# West Oakland Link Initial Study/ Mitigated Negative Declaration Addendum

**NOVEMBER 2024**

### 1.3 Proposed Revised Project

Figure 1-6b

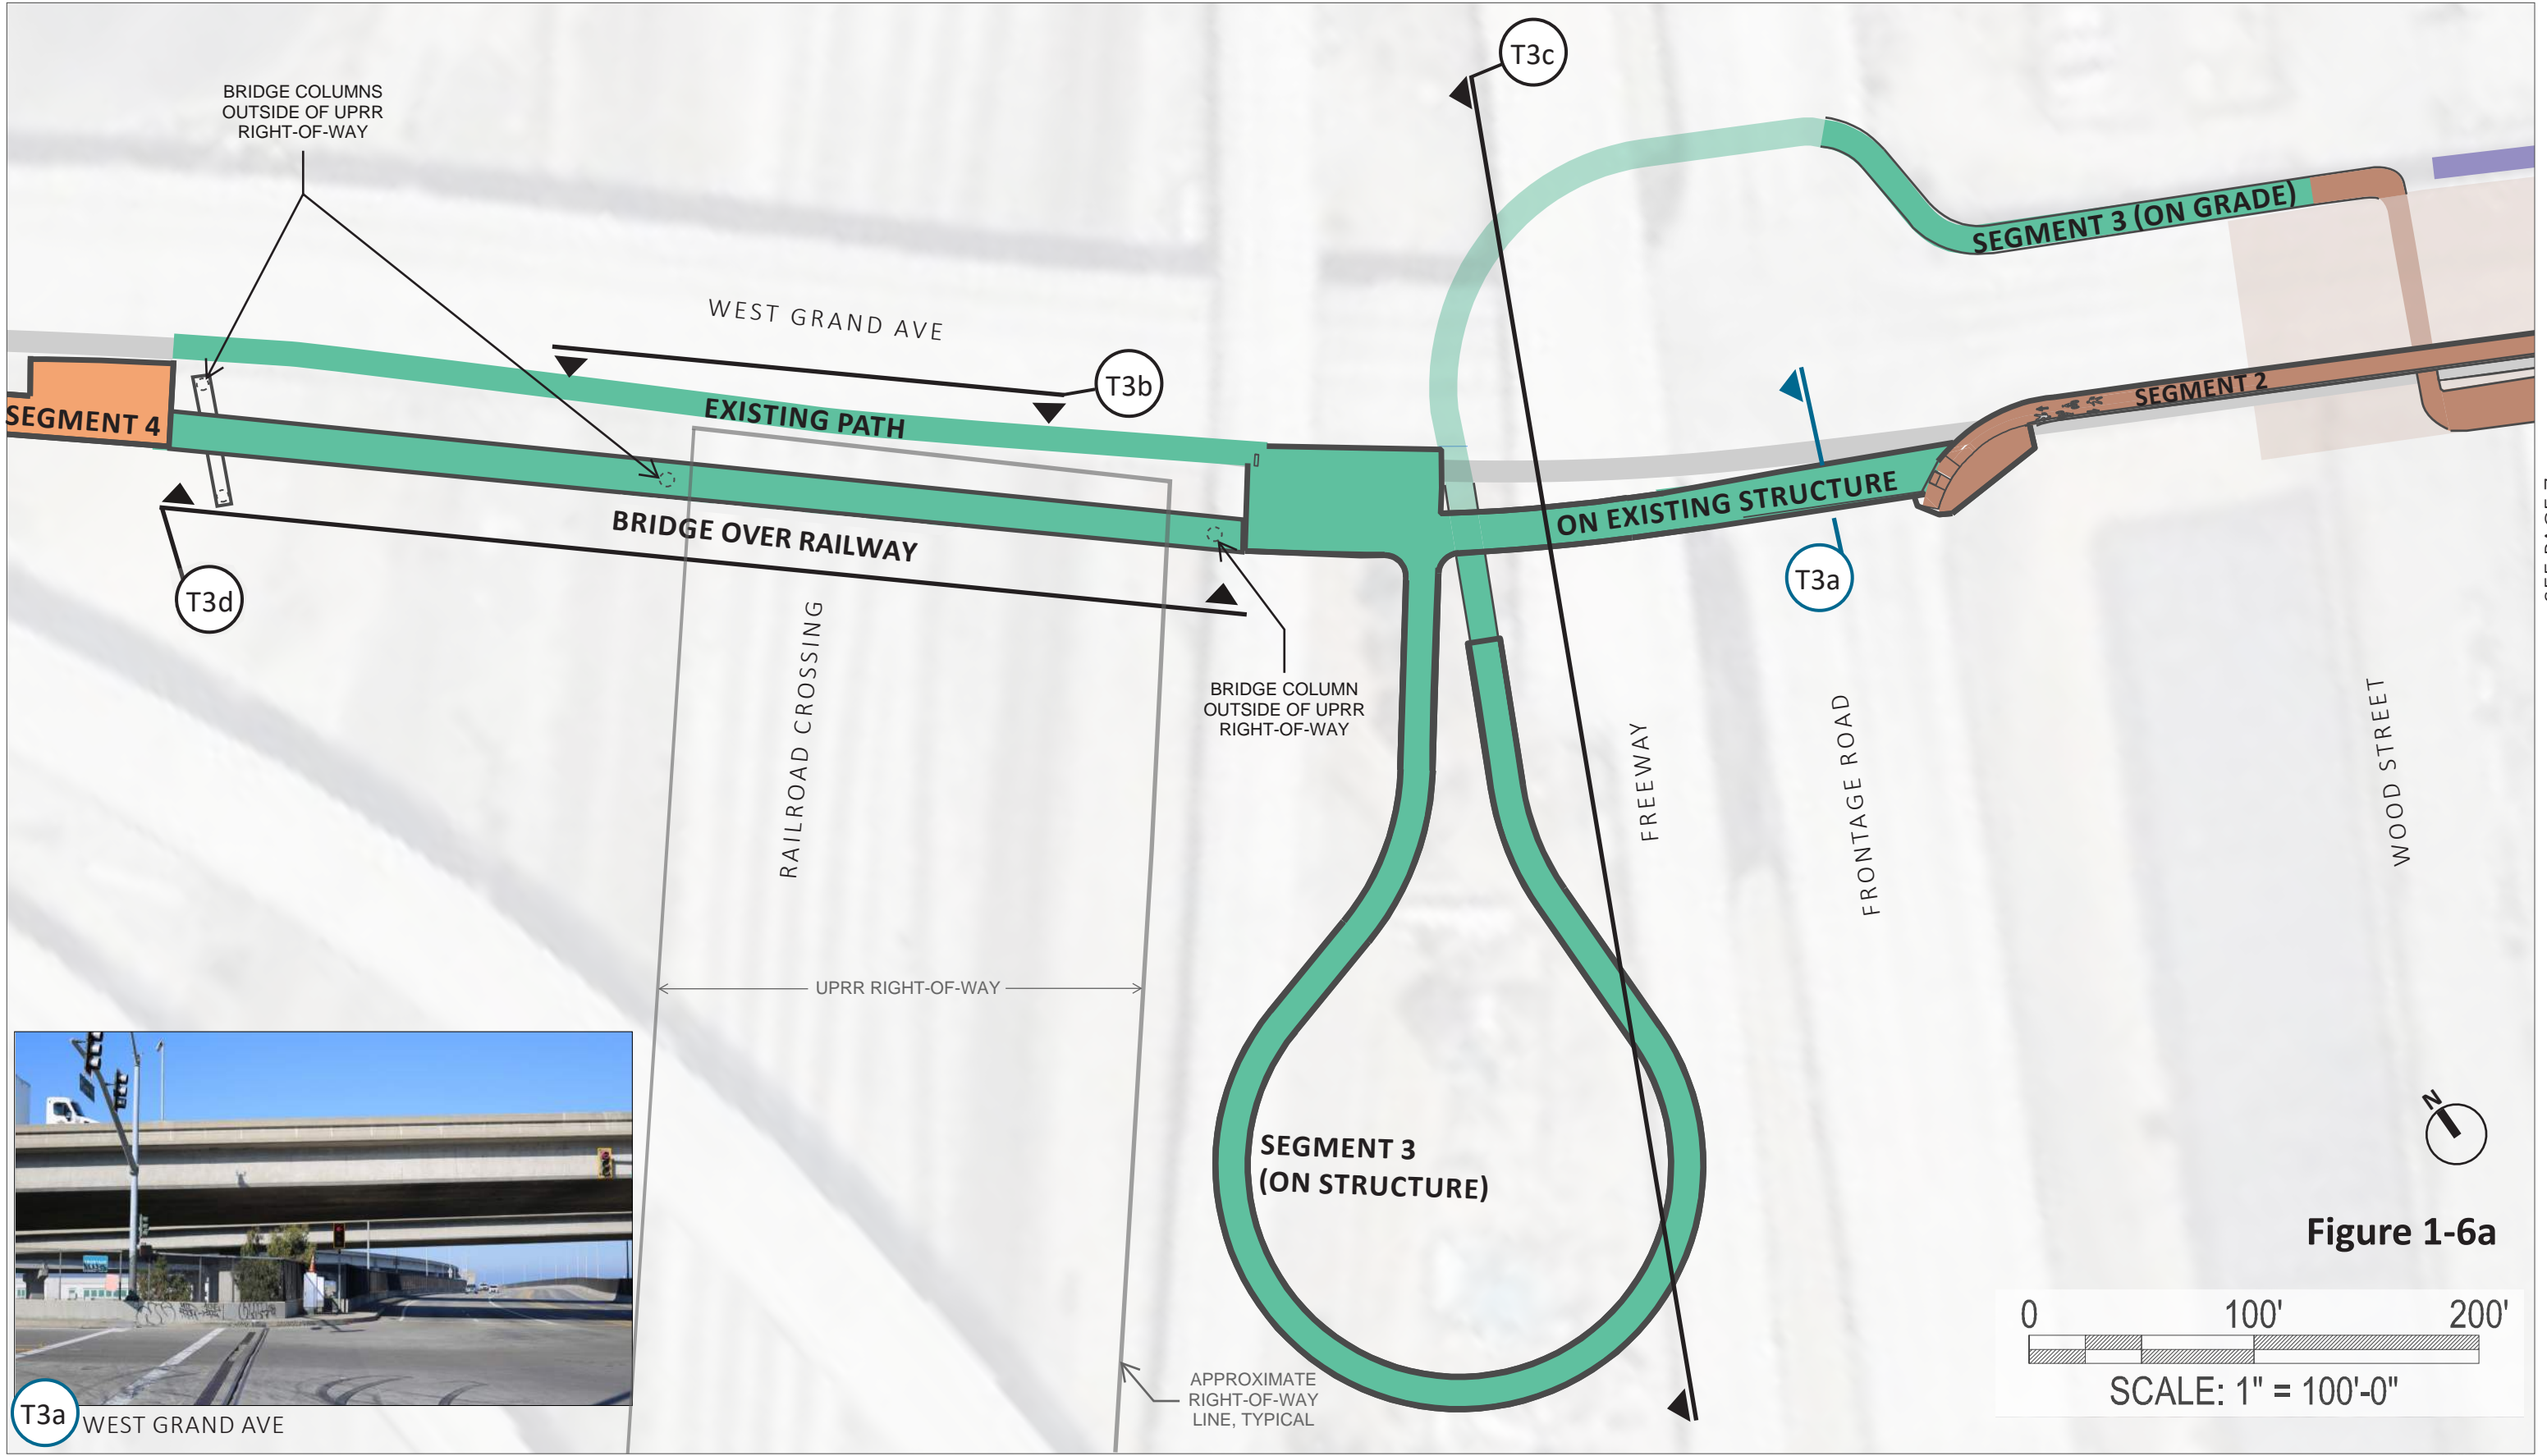
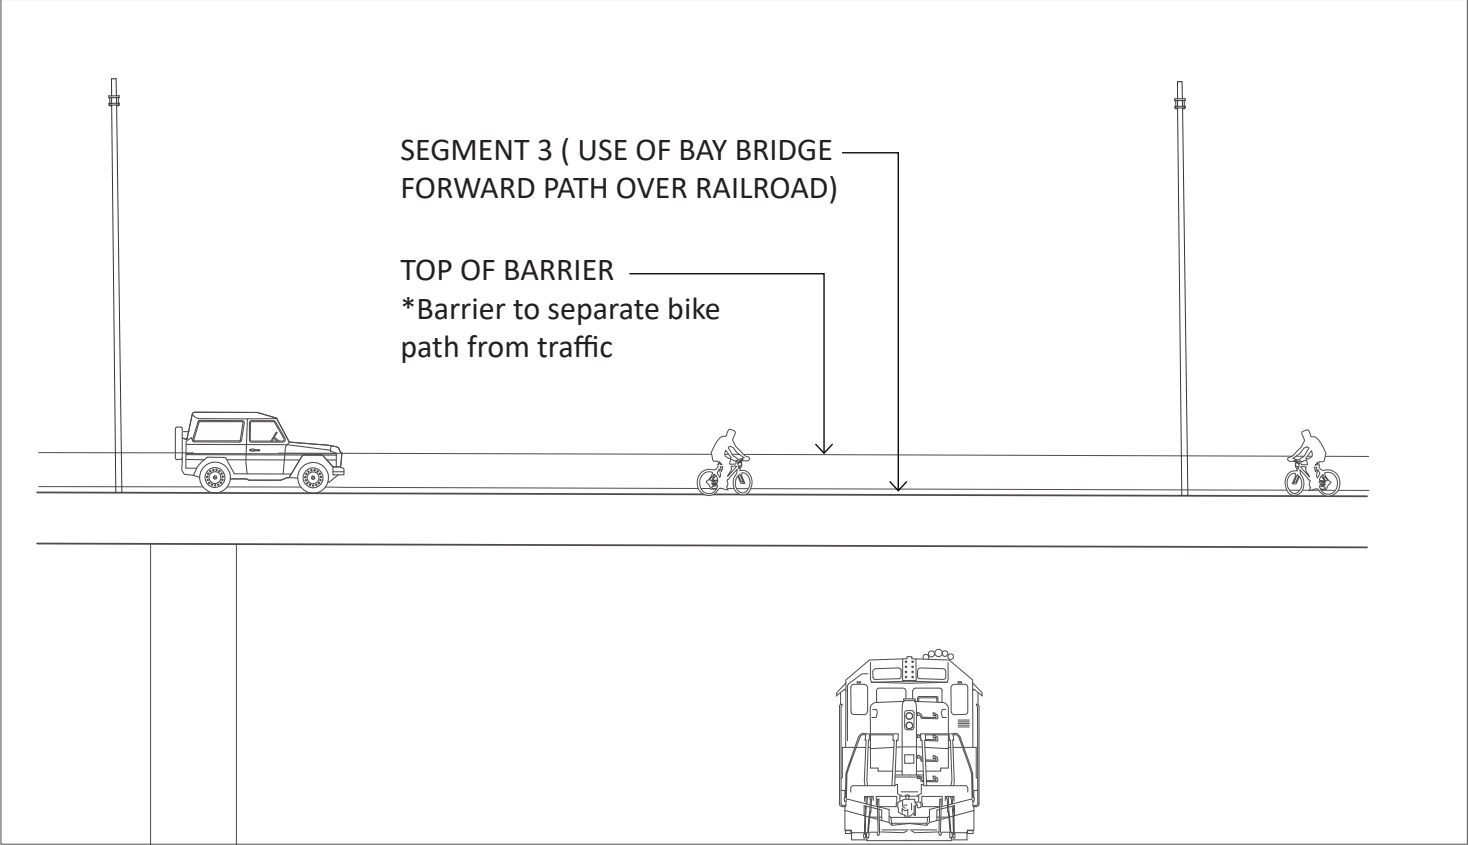
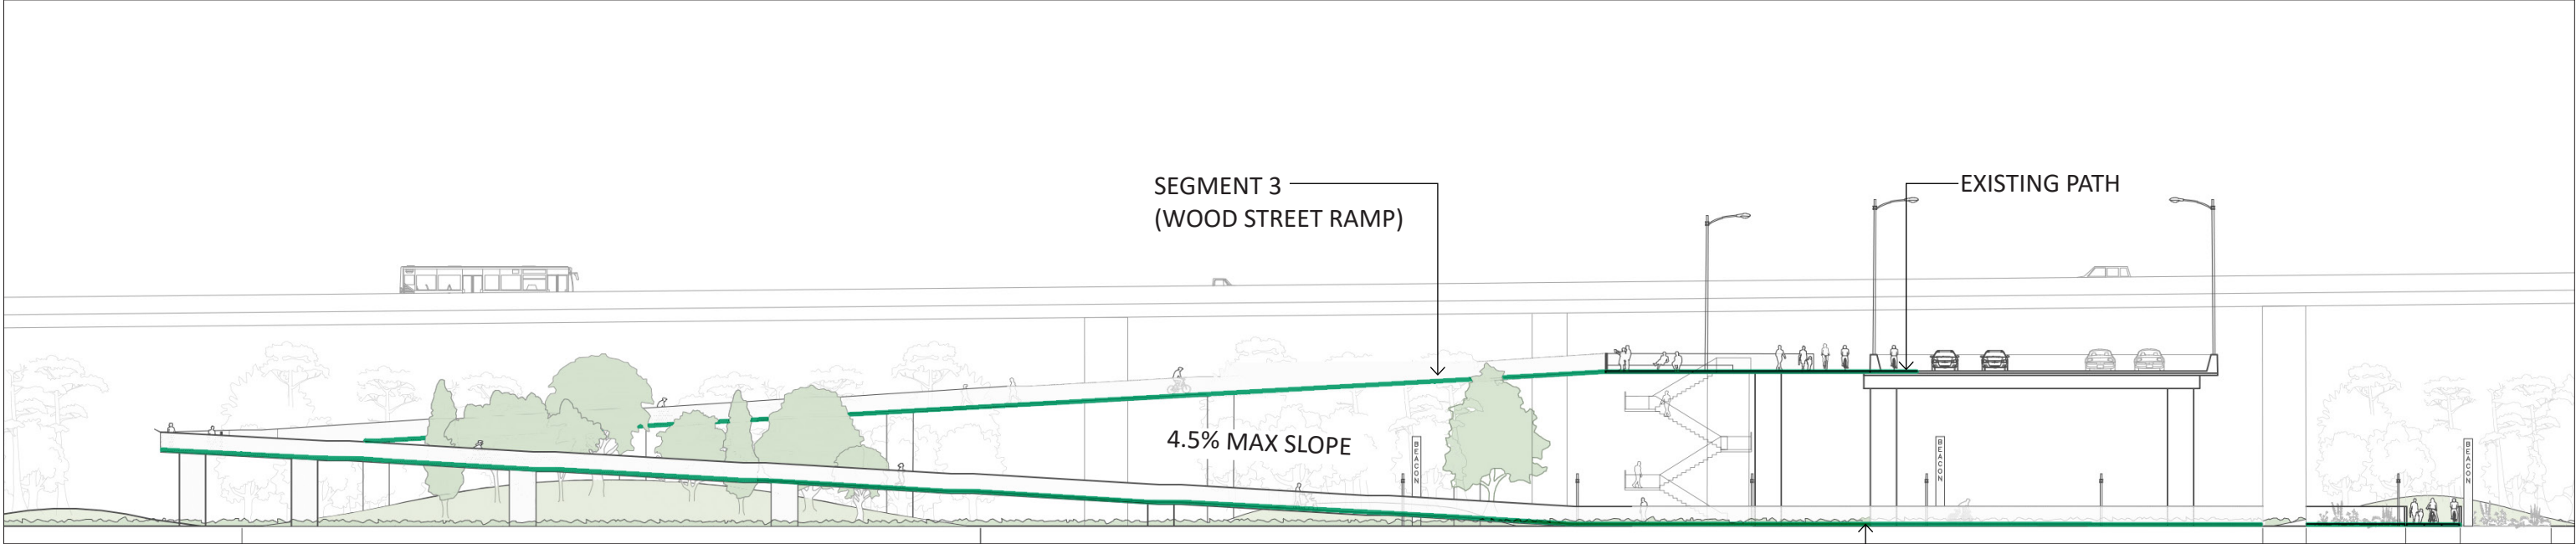
As shown in Figures 1-6a and 1-6b, Segment 3 Path 1 of the Proposed Revised Project would continue to the west of the Wood Street overcrossing as a separated path for approximately 250 ft. and connect to the 8-ft. wide multiuse pathway to be constructed as part of the Bay Bridge Forward West Grand Avenue HOV Lane project. Segment 3 Path 2 would continue west and cross Wood Street at-grade before transitioning into a 12-ft. wide multi-use pathway underneath the Frontage Road and West Grand Avenue structures. The users can then use a loop ramp or a stair to reach the multiuse pathway to be constructed as part of the Bay Bridge Forward West Grand Avenue HOV Lane project. In addition, an elevator may also be constructed in the future to connect the 12-ft. path to the 15-ft. path. At the top of the loop ramp, the structure will be wider to accommodate a seating area, benches, and shade structures that would be set back from the bicycle and pedestrian path..

Figure 1-6c

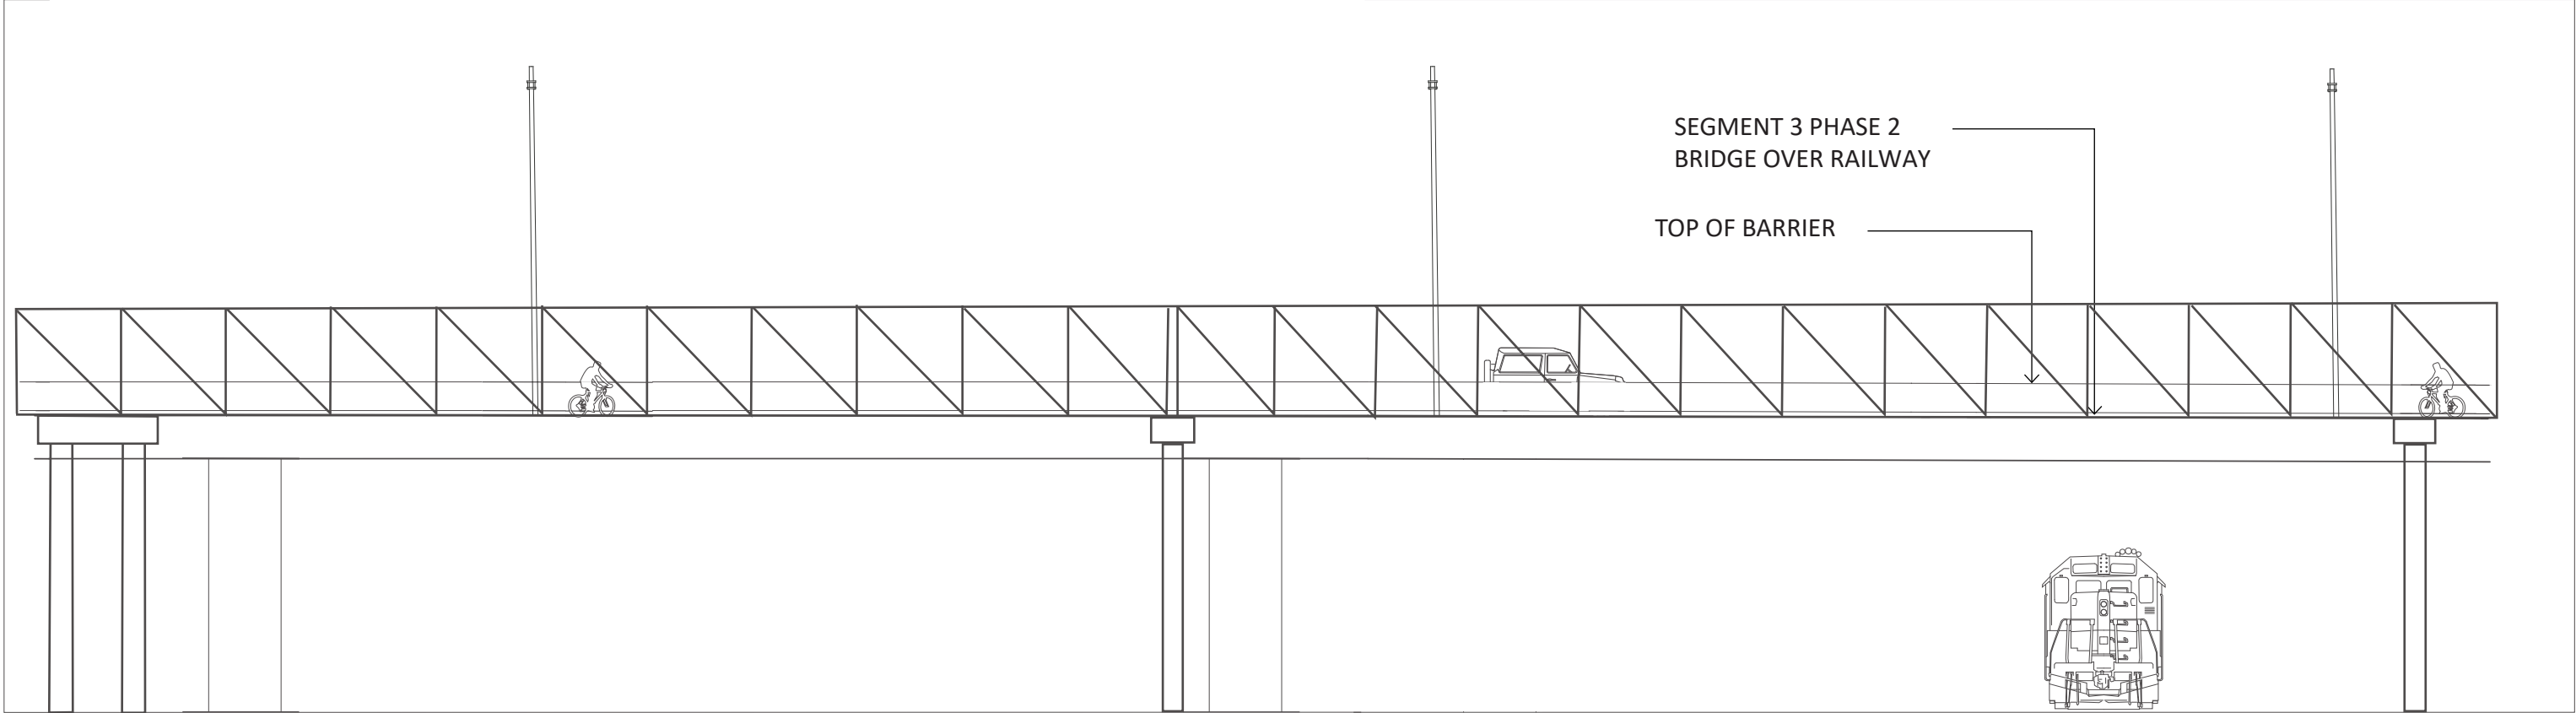
Phase 2 of Segment 3 includes the construction of a 460-ft. prefabricated steel truss bridge spanning over the UPRR right of way. The bridge will have a 15-ft clear width. The columns for the proposed bridge will be within the Caltrans right of way. The Port of Oakland has a surface easement with Caltrans where one column location is being proposed. The placement of columns within the leased area will accommodate the Port of Oakland's future rail development plans. The proposed truss bridge consists of two spans: one over UPRR right-of-way (east span) and the other over the Port of Oakland surface easement (west span). The proposed bents are located outside of UPRR's right-of-way and exceed the 25-foot horizontal clearance requirements for pier protection. The bridge also provides over 30-ft of vertical clearance, which exceeds the 23'-4" (UPRR) and 23'-6" (BNSF) requirements. To minimize impacts to rail operations, it is proposed that this bridge be prefabricated offsite and craned into place during a limited shutdown period. The bridge will include mesh fencing 10-ft high to protect patrons and to prevent objects from falling onto the tracks. Additionally, column construction will not affect rail operations since these locations are
